Kent's Highways service

to create awareness and gain support for improvement
and better maintenance services for pavements,
lampposts and signage in Royal Tunbridge Wells

Case 2 - Mount Pleasant and Crescent Road - Streetlights

15 / LMCZ004
Mt. Pleasant

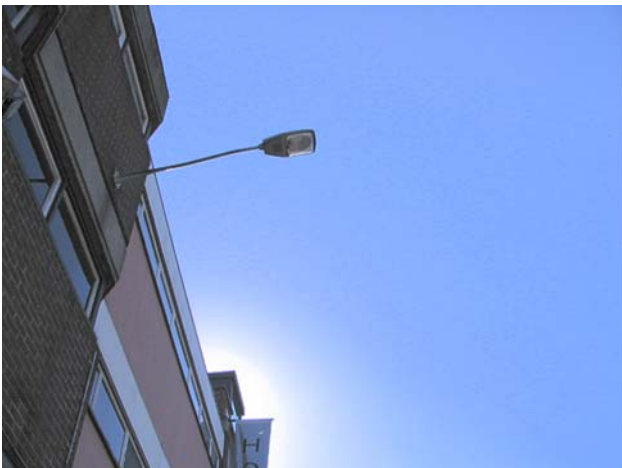
1) light on during day
